Subject: McGuire Nuclear Station  
Docket Nos. 50-369 and 50-370  
Preservice Inspection Plan

Requests For Relief From  
Inservice Inspection Requirement  
McGuire Nuclear Station

ATTACHMENT 2

ND Heat Exchanger  
Inaccessable Nozzle Welds

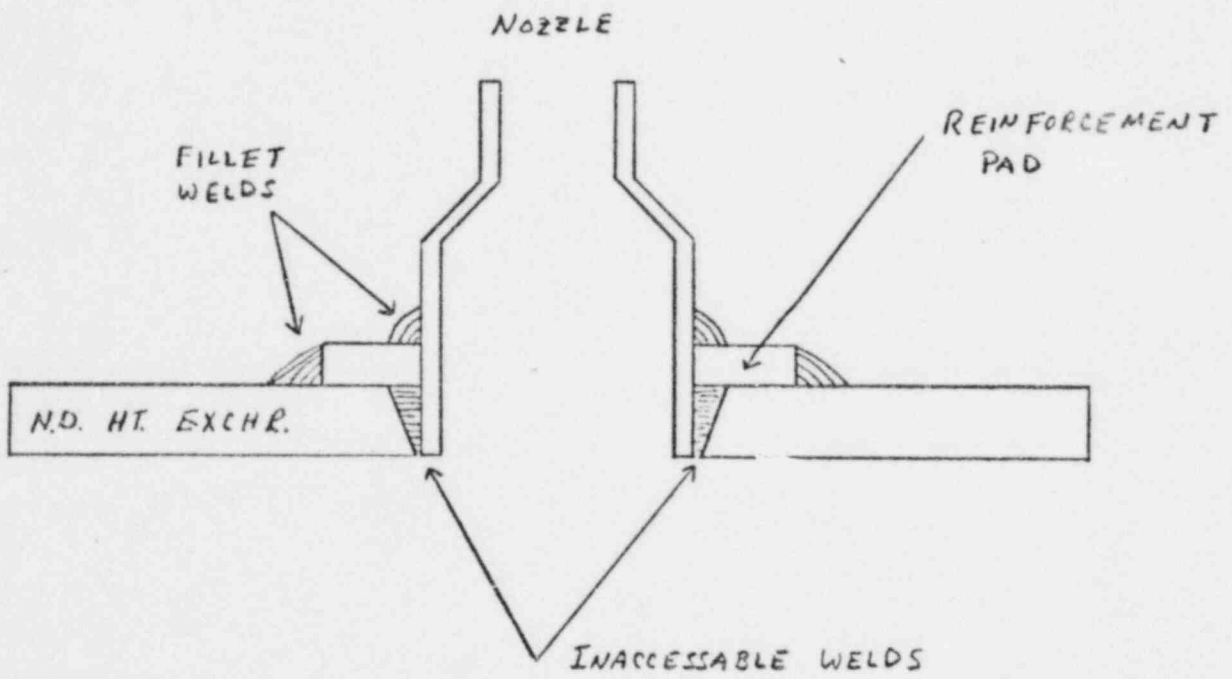
- Function:  
Primary Coolant Heat Removal
  - ASME Section III Code Class:  
Class II
  - Valve Category: NA
- II. Reference Code Requirement that has been determined to be impractical:  
Category C-B Item C1.2 Volumetric examination of nozzle to vessel welds  
(2 per heat exchanger). Due to welded collar, the nozzle to vessel welds  
are inaccessible. See attachment I.

- III. Basis for Requesting Relief
- Material - Shell SA-240 Type 304 SS, Nozzles SA312 Type 304SS  
Estimate of preservice examination performed - 0%  
Original fabrication examination - Radiography and dye penetrant examination  
Measures which would be required to make the area accessible - Removal of  
the welded collars  
Reference Drawing - Sketch Attached

To grind off the welded collars would not justify the high cost and loss of time to inspect the nozzle to vessel welds. The shop examinations provide adequate assurance of component reliability.

The fillet welds attaching the collar to the nozzle and shell will be examined with dye penetrant. The vessel has been hydrostatically tested with no evidence of leakage.

Inservice inspections will include a surface examination of the collar welds and hydrostatic tests.

Steam Generator  
(Typical of 4)

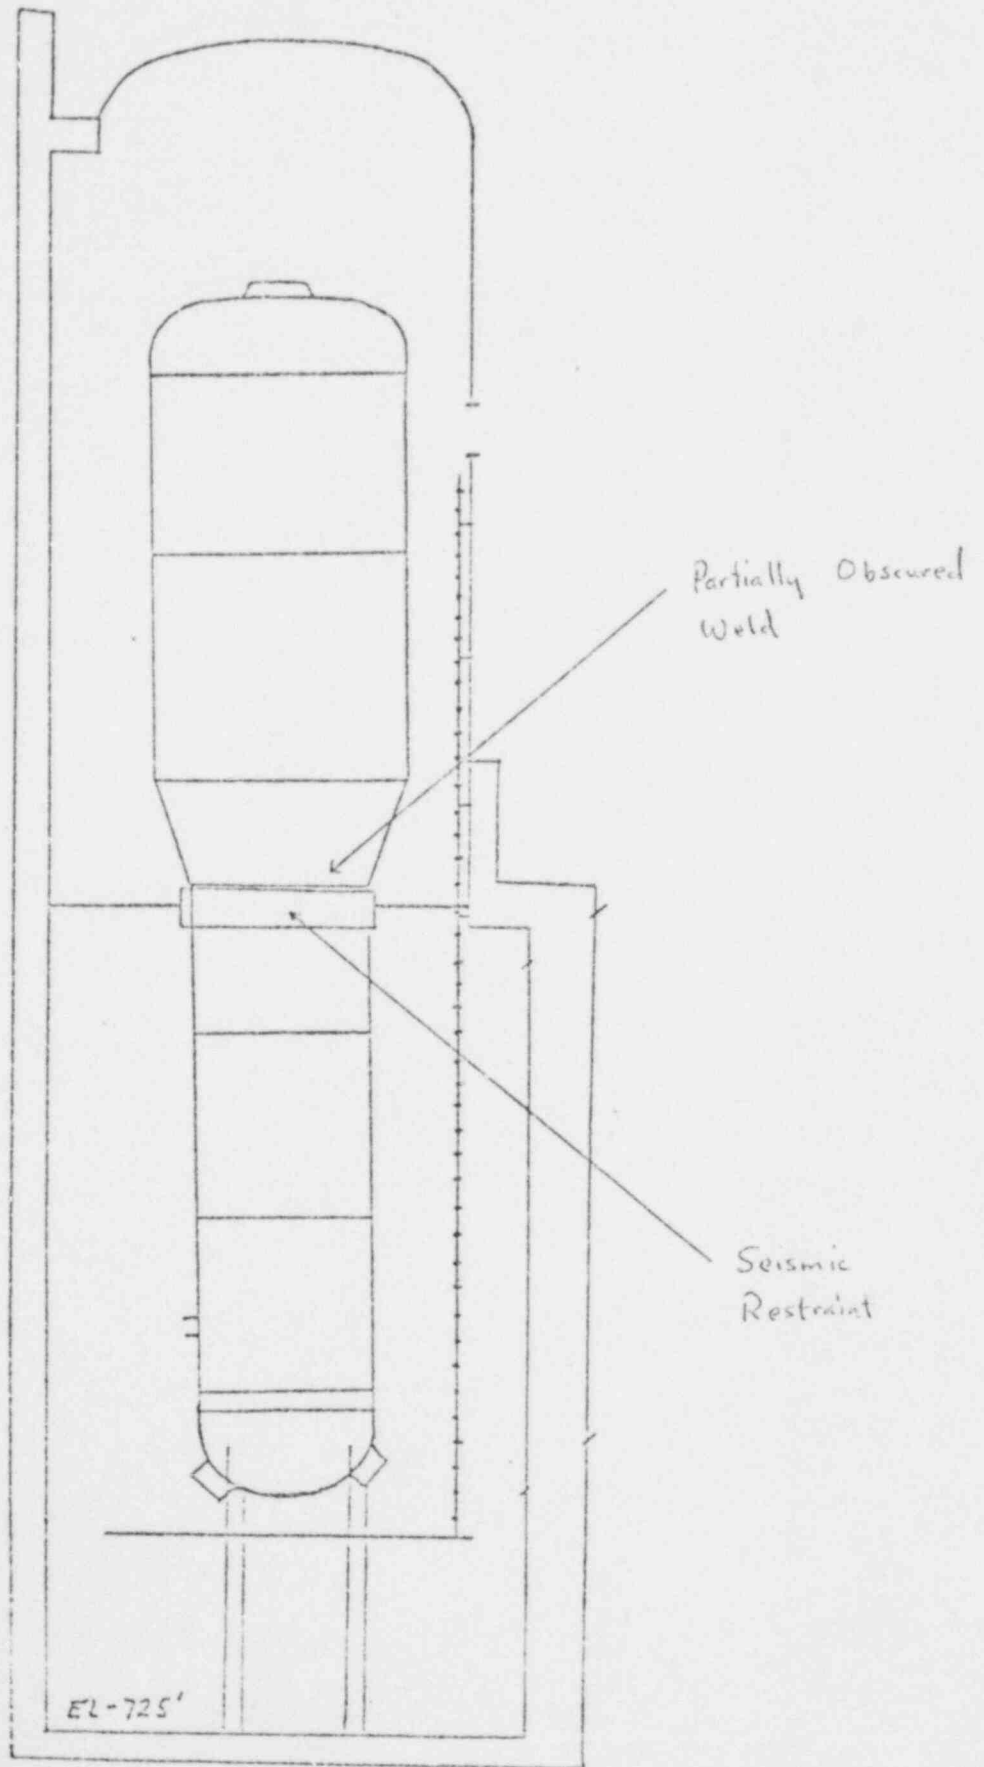
II. Reference Code Requirement that has been determined to be impractical:  
Category C-A Item CI.1 of Table ISC-261 volumetric examination of  
steam generator transition cone to lower shell barrel circumferential  
weld. Due to location of seismic restraint, approximately 60% of the  
weld is obscured.

The welds in question have been ultrasonically tested from one side using 0°, 45°, and 60° transducers. Due to the location of the restraint, it is impossible to perform the 0° scan on the weld centerline or the 45° and 60° scans from the lower side of the weld. All other steam generator welds are accessible. It is believed that the limited scan plus the periodic hydrostatic tests provide adequate assurance of weld integrity. The high cost in time and money does not justify relocating the seismic restraint.

Inservice inspections will be performed by using the limited scan described above.

Steam Generator  
Nozzle-to-pipe  
Safe-End Weld

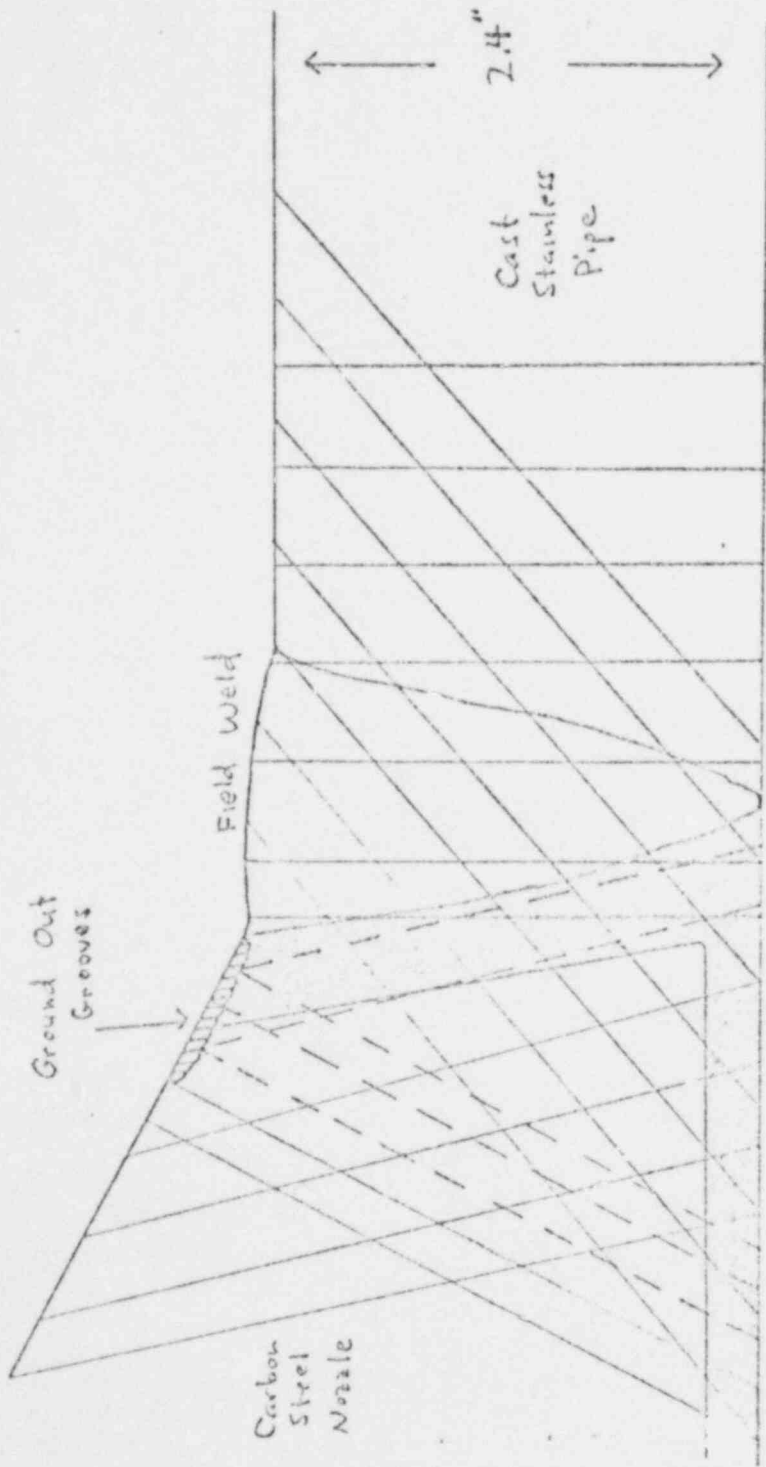
Category F Item 3.3 of Table IS-261 Volumetric examination of primary nozzle to safe-end welds. Due to presence of ground out areas and the contour of the nozzle, the safe-end weld cannot be fully inspected.

The ground out areas are present on all eight nozzle to safe-end welds and vary in depth from 1/32 inch to 1/8 inch. As can be seen from the attached sketch, the ground-out areas only slightly limit the ultrasonic scan. Both the manufacturer and an outside consultant have recommended that cosmetic welding not be performed. Because of our concern that cosmetic welding might be deleterious to the weld joints, this request for relief is submitted.

The welds have been examined ultrasonically, visually, and with dye penetrant in accordance with the Section XI Code.

Inservice inspection will be performed in accordance with the Section XI Code Edition specified by 10CFR55.55 a, paragraph (g). In addition, the welds will be examined using liquid penetrant every third refueling outage.

FIGURE 1

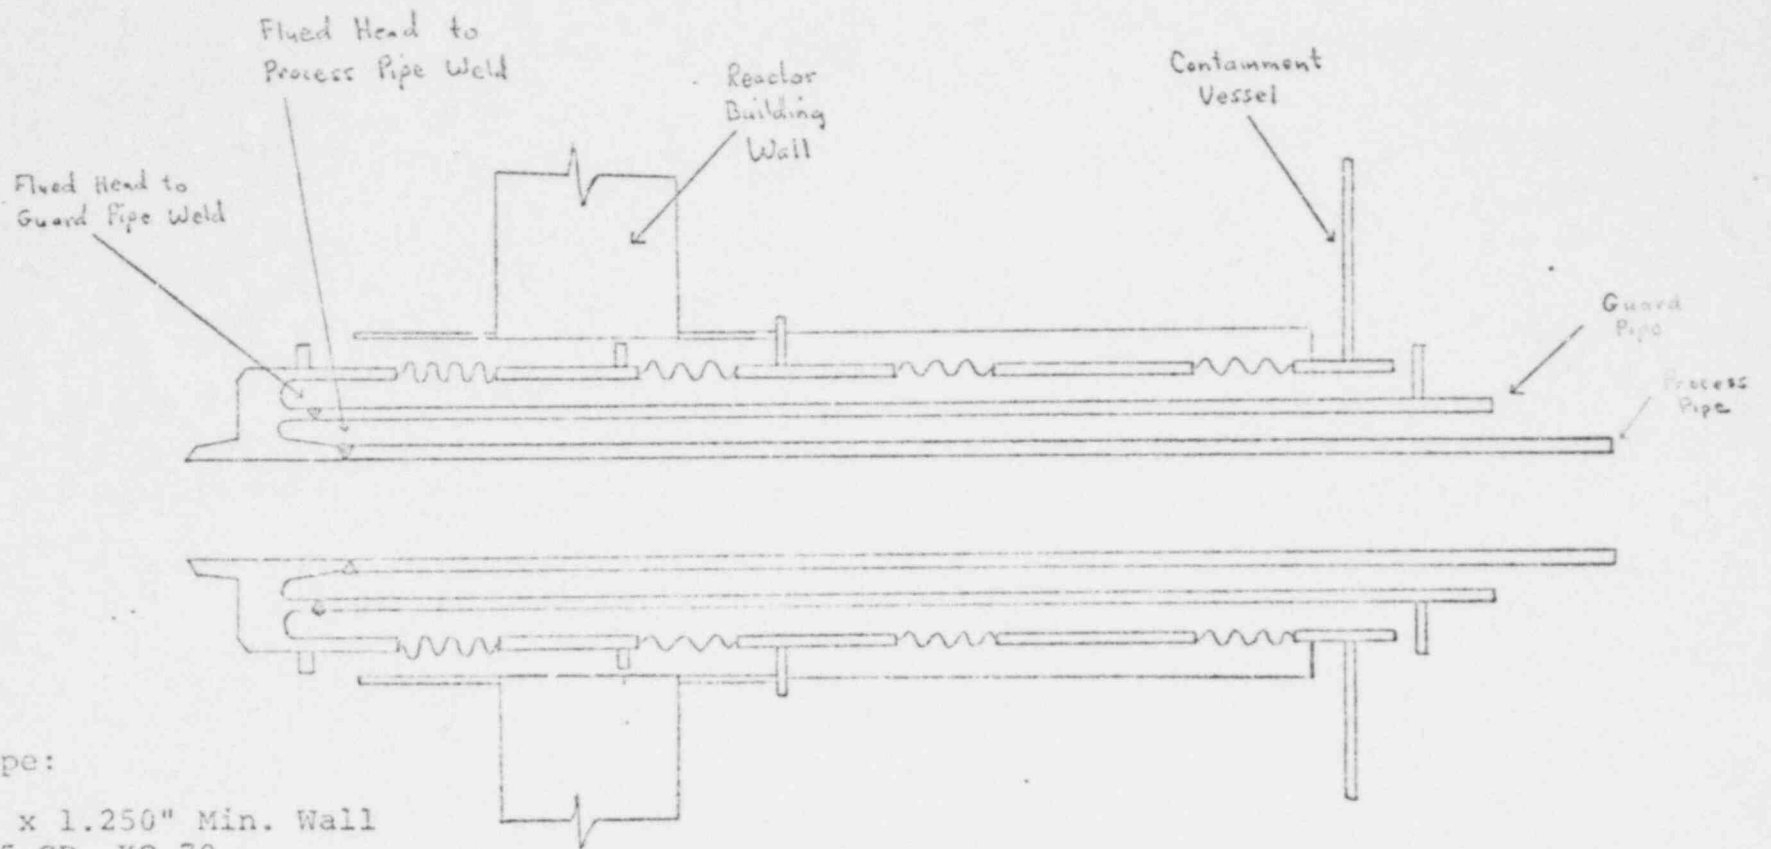
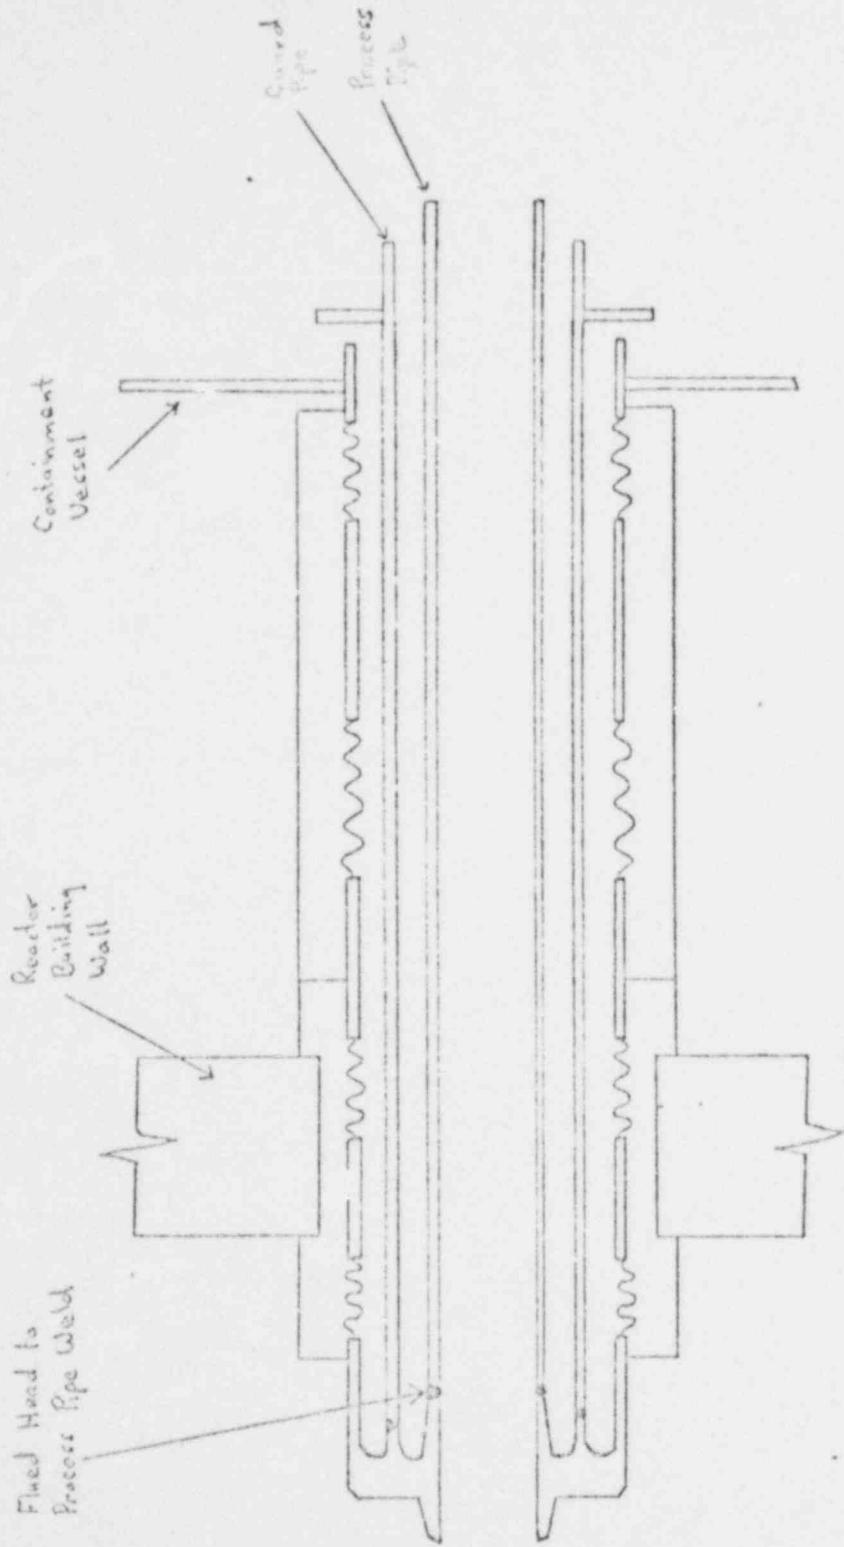
Categories C-F, C-G - Item C2.1 of Table ISC-261 volumetric examination of piping circumferential butt welds. Due to the design of the penetration assemblies, the penetration flued head to process pipe welds are inaccessible. In addition, the Type I and Type II penetration flued head to guard pipe welds are inaccessible.

At the time of purchase, the penetration assemblies were state of the art in design and manufacturing technique. Redesign and replacement would result in extended delay and enormous cost. Component integrity can be assured with examination of similar welds in the process pipe coupled with hydrostatic tests and penetration leak tests.

Piping systems have been hydrostatically tested and penetrations will be leak tested.
